Technical Service Bulletin: tsb101469

Revised Cylinder Liner Diameter Measurement

This Service/Parts Topic updates a change made to the QSK45 and QSK60 series engines. The topic provides details on Cylinder Liner Inner Diameters when installed in an engine block.

Figure 1

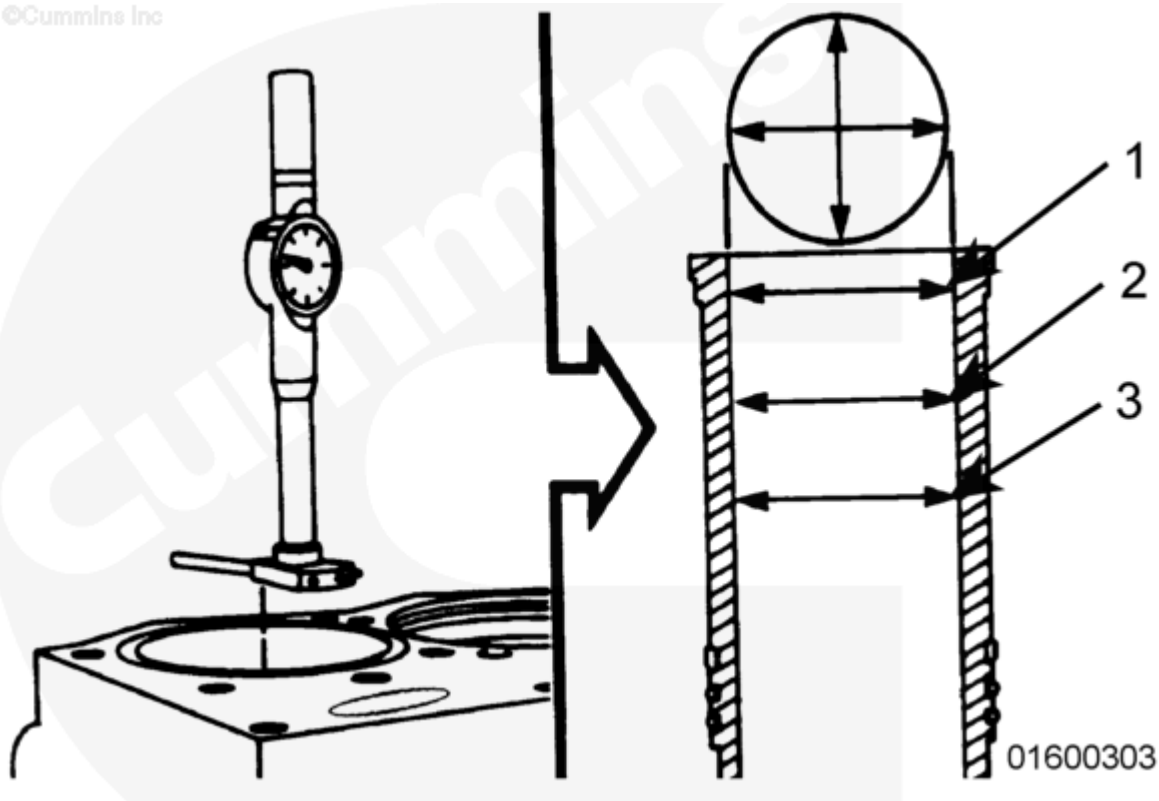
Diametrical measurements **must** be taken at the positions specified in Figure 1 and Table 1.

- Position 1 = 20 mm [0.8 in] from top of liner
- Position 2 = 115 mm [4.5 in] from top of liner
- Position 3 = 205 mm [8.0 in] from top of liner.

At each specified position, two measurements **must** be taken. The measurements **must** be 90 degrees apart. Ensure that the measurements taken fall within the limits specified within the table below.

The inner diameter **must** be **no more** than 0.064 mm [0.0025 in], out of round at each location.
